## ADDENDUM NO. 1

PROJECT: Saline Area Schools – 2022 Bond Program – MS Rec Complex  
 DESCRIPTION: Addendum No.1  
 BID PACKAGE RELEASE NUMBER: BP #3

1. ADDENDUM No. 1, November 20<sup>th</sup>, 2024 as issued by Kingscott (Attached)
2. Bid Package T4 Draft Drawings, October 22<sup>nd</sup>, 2024 - Saline Middle School Rex Complex as issued by Barton Malow (For Reference Only)

SHEET NO.  
**C6.3**

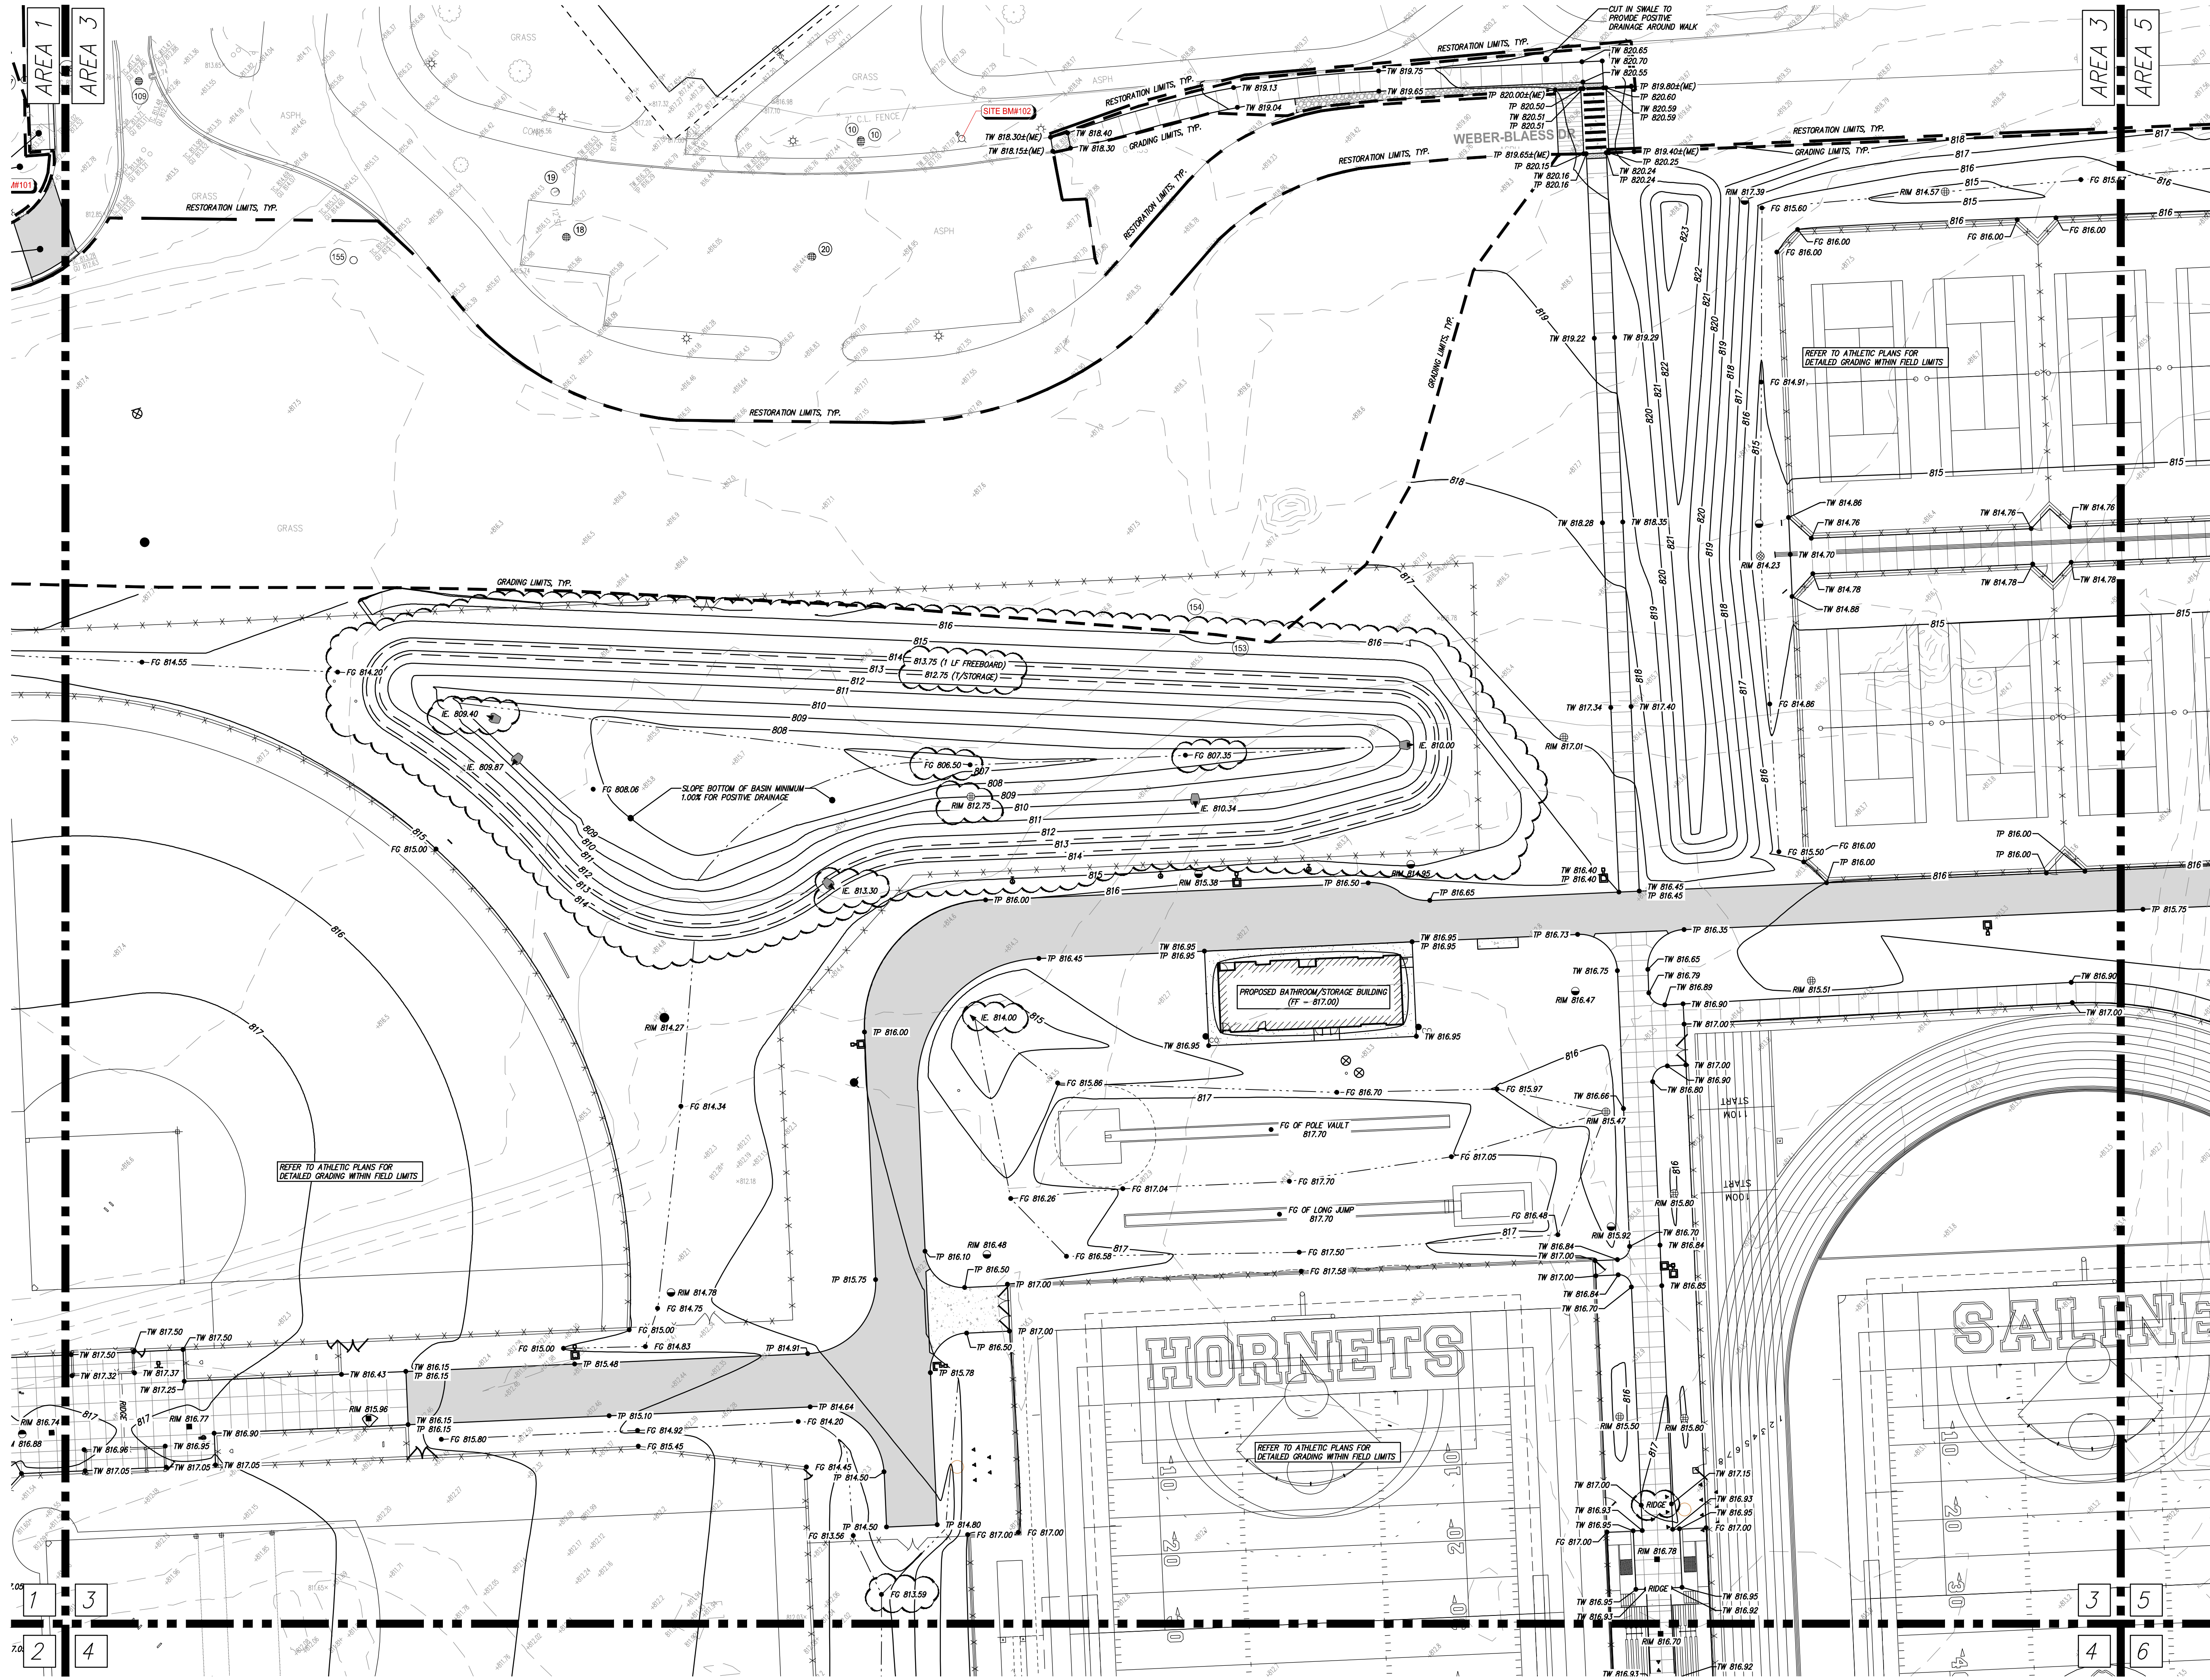
- Item No. 65: Added additional spot grades on sheet C6.2.
- Item No. 66: Updated inverts and rim elevations per utility layout changes on sheet C6.2.
- Item No. 67: Revised basin grading on sheet C6.3.

- Item No. 68: Added "Top of Storage" and "Freeboard" elevations on sheet C6.3.
- Item No. 69: Updated spot grades per grading changes on sheet C6.3.
- Item No. 70: Updated inverts and rim elevations per utility layout changes on sheet C6.3.

- Item No. 71: Added "Ridge" location and label on sheet C6.3.

SHEET NO.  
**C6.4**

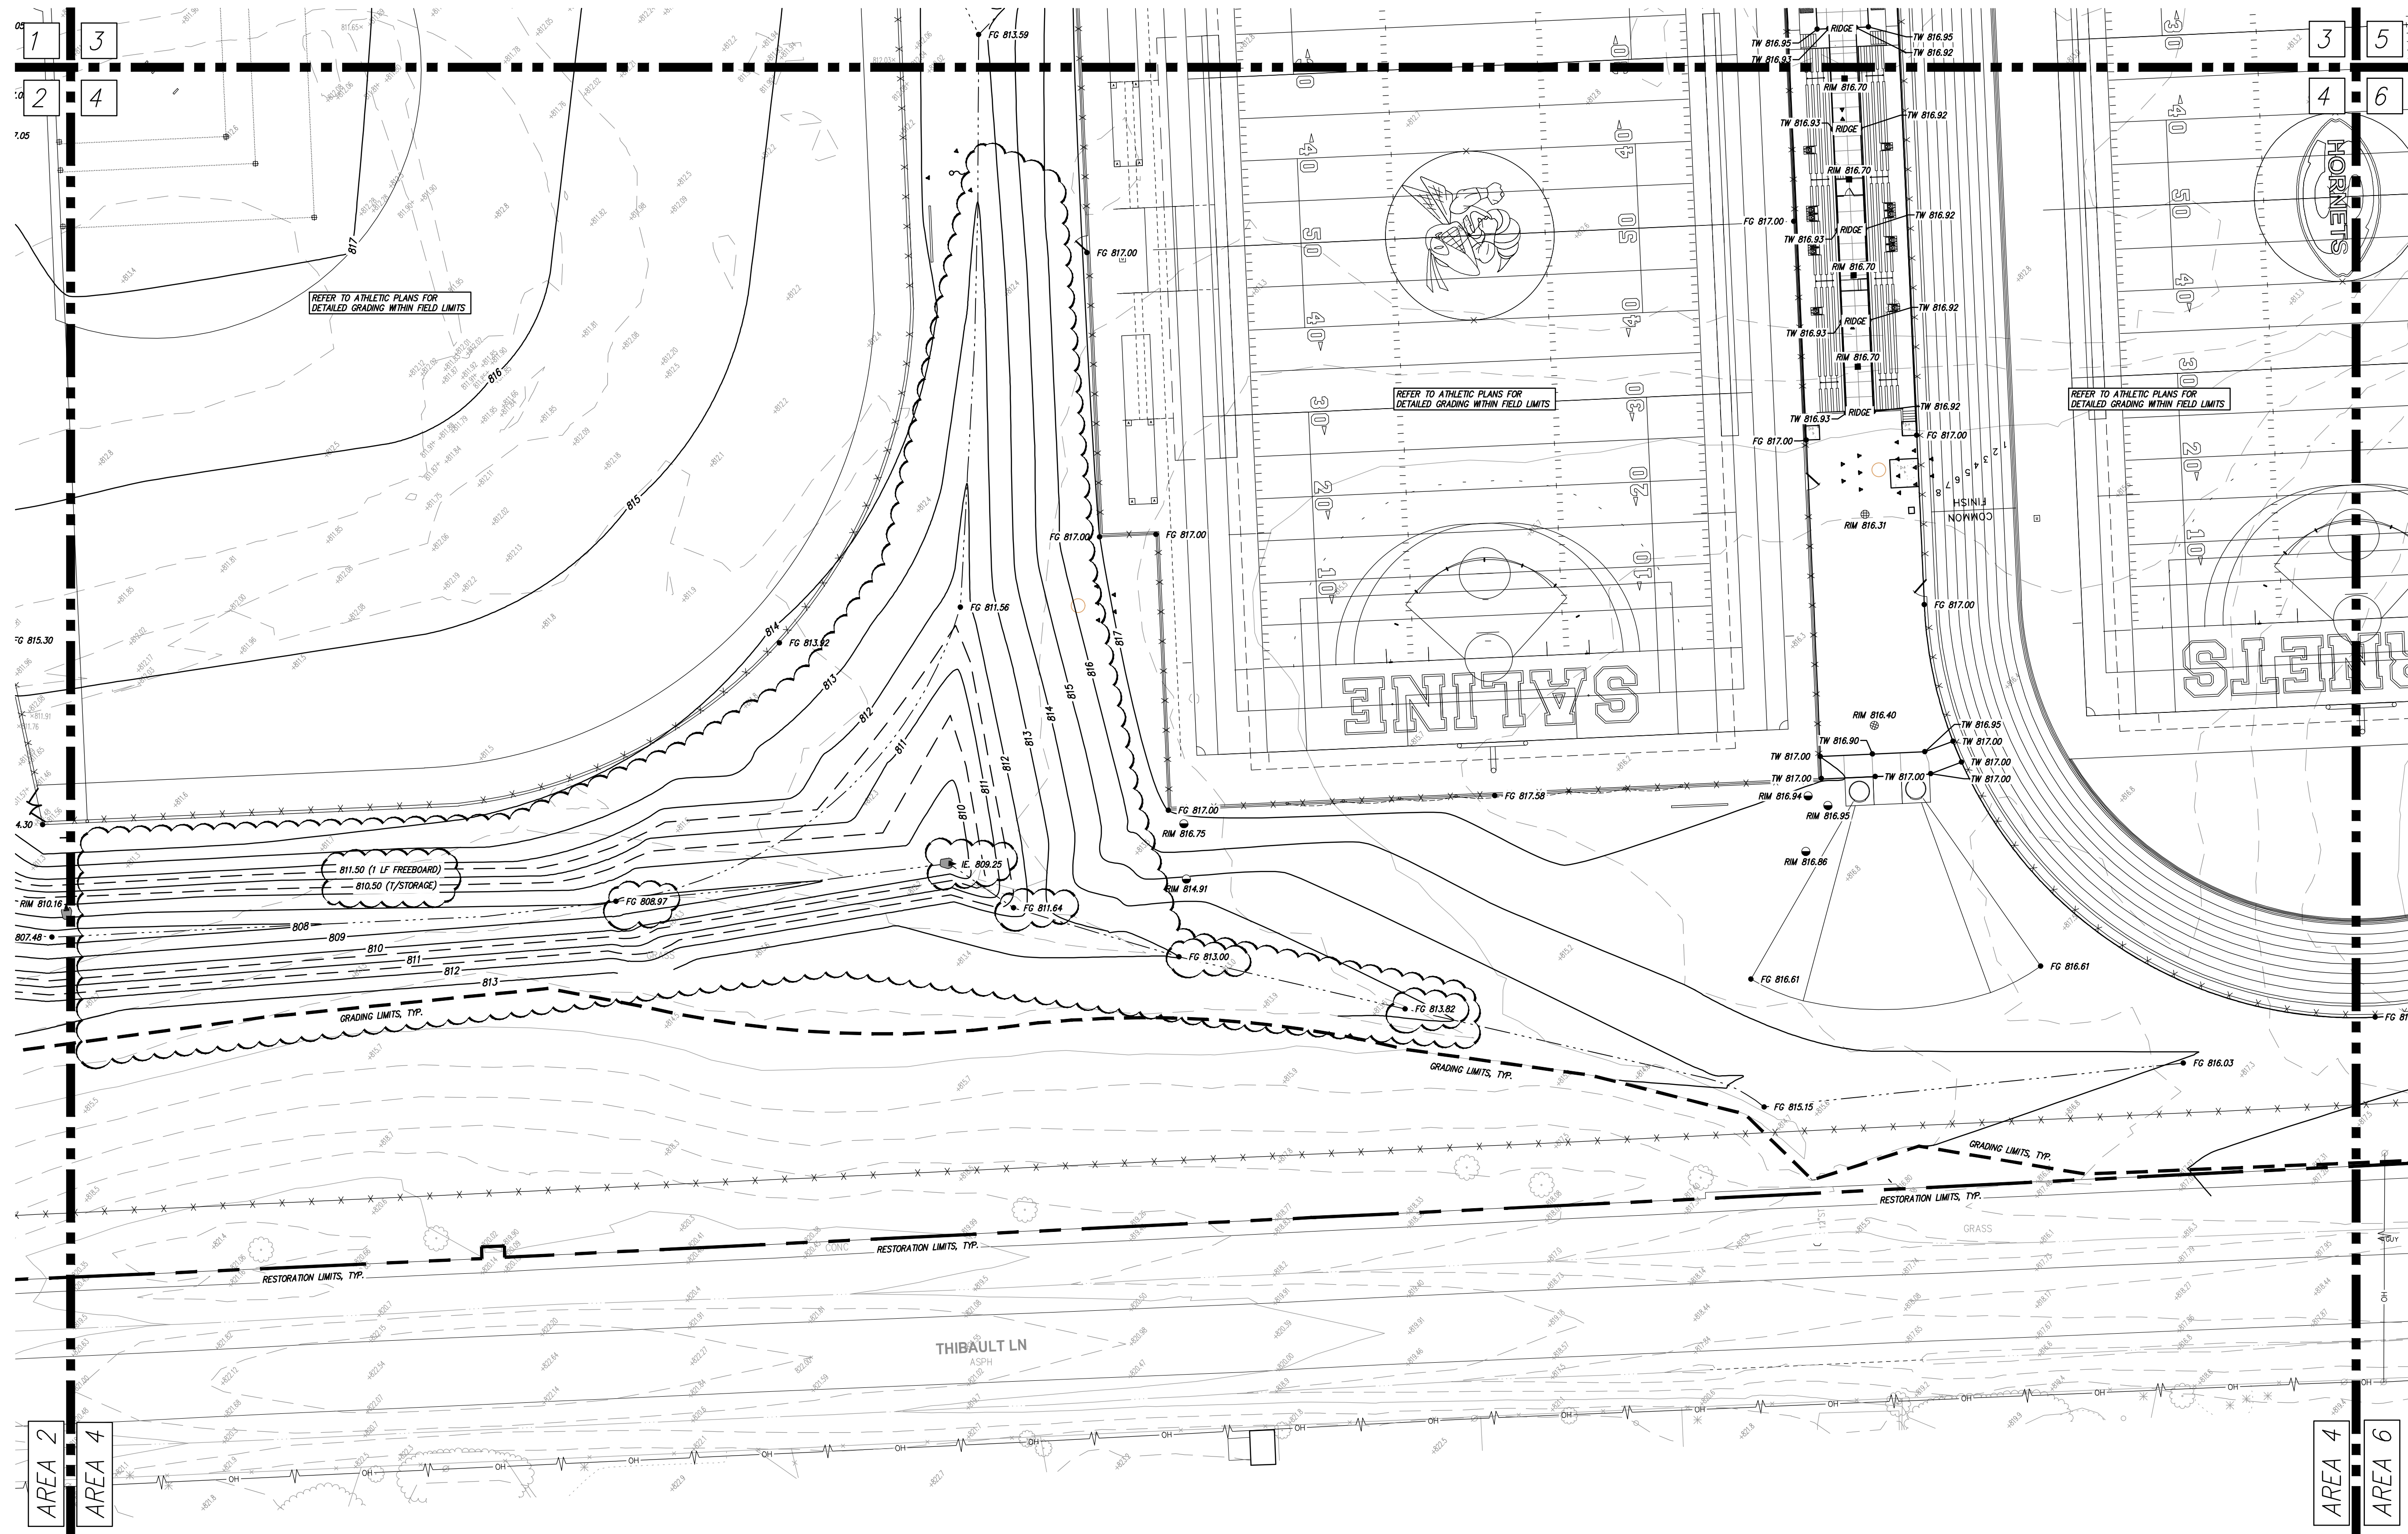
- Item No. 72: Combined "Basin C" and "Basin D" into one basin on sheet C6.4.
- Item No. 73: Added "Top of Storage" and "Freeboard" elevations on sheet C6.4.

- Item No. 74: Updated spot grades per grading changes on sheet C6.4.
- Item No. 75: Updated inverts and rim elevations per utility layout changes on sheet C6.4.
